DOCUMENT CHANGE NOTICE (DCN)

DOCUMENT No. (DOC-REV-GP. ID)	TITLE	NEW REV.
D961416-A	Large Core Optic Component Carrier Cover	B
D961449-A	Core Optic Component Carrier Top Plate	B
D961467-A	Core Optic Component Carrier Metrology Interface Top Plate	B

D961449:

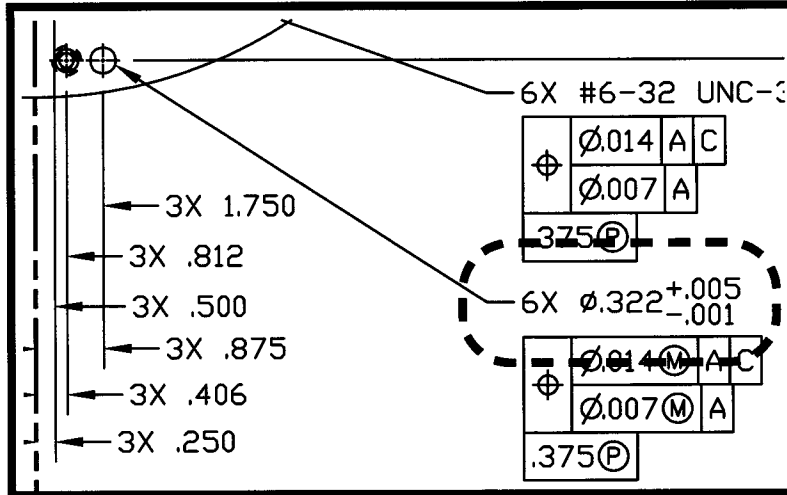
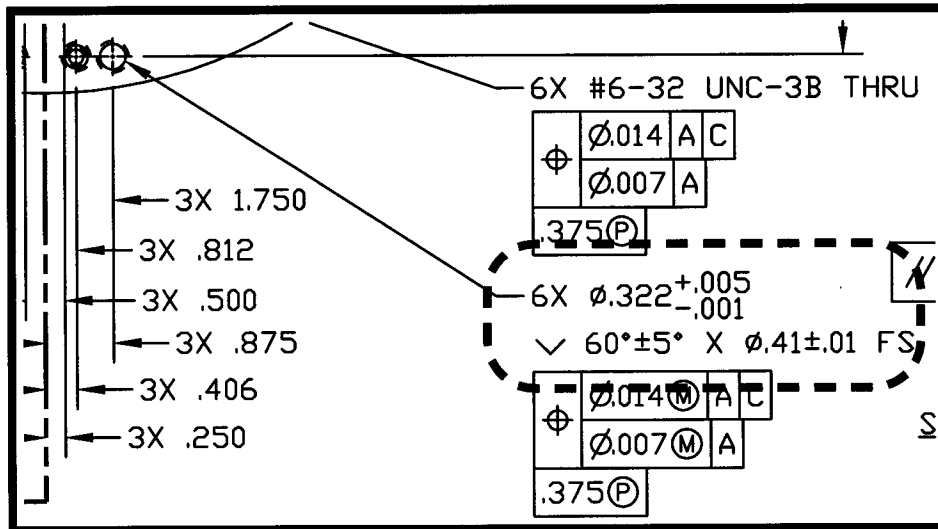
Added countersinks to bottom side of plate on six clearance holes as shown:

REASON FOR CHANGE: Alleviate “wedging” of captive screw retaining rings D970001, between top of standoffs and bottom side of top plate D961449 on top assemblies D961460 & D961461. This problem caused the retaining rings to ride down the captive screw threads when backing out the captive screws to remove the top plate.

D961467:

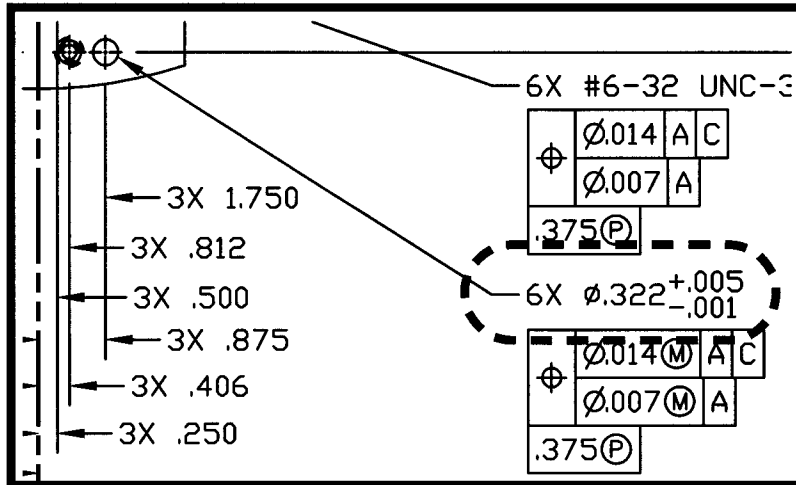
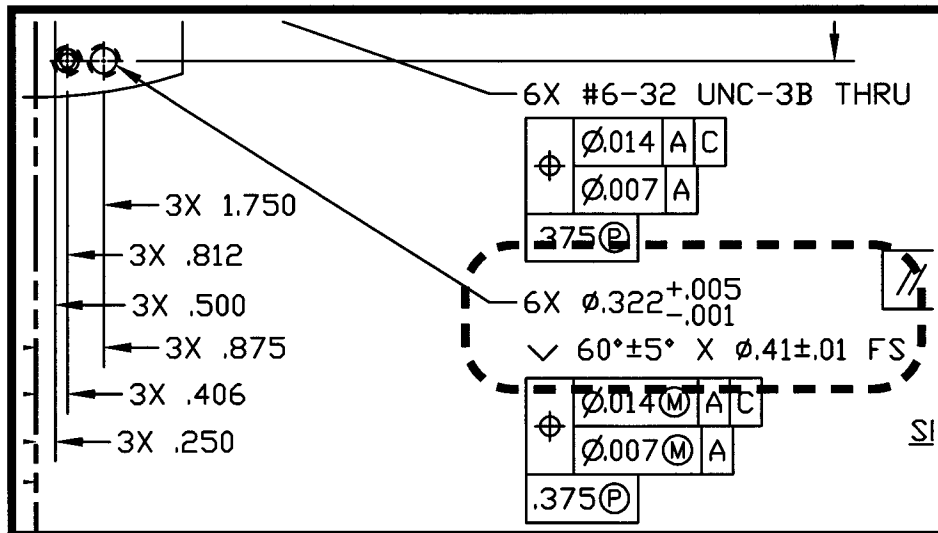
Added countersinks to bottom side of plate on six clearance holes as shown:

REASON FOR CHANGE: Alleviate “wedging” of captive screw retaining rings D970001, between top of standoffs and bottom side of top plate D961467 on top assemblies D961460 & D961461. This problem caused the retaining rings to ride down the captive screw threads when backing out the captive screws to remove the top plate.
